Statement

We, NETPRISMA INC., declare on our sole responsibility for the product of LCUK54-WWD (FCC ID: 2BEY3LCUK54WWDA) & LCUK54-WRD (FCC ID: 2BEY3LCUK54WRDA) as below:

Component Placement

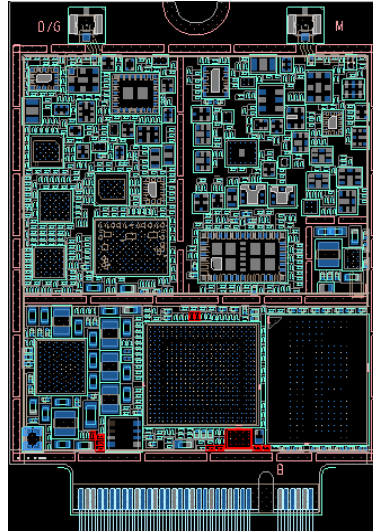
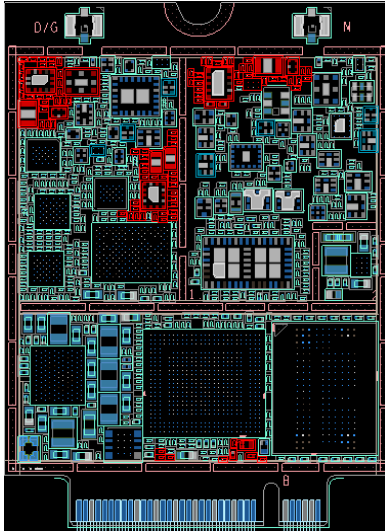
- PCB Layout changes: No
- Antenna change: No
- PA change: NO
- Adding or reducing materials: Yes (Compared with the prototype LCUK54-WRD, the LCUK54-WWD adds B42/43/48 related components.)
- Shield case: Yes
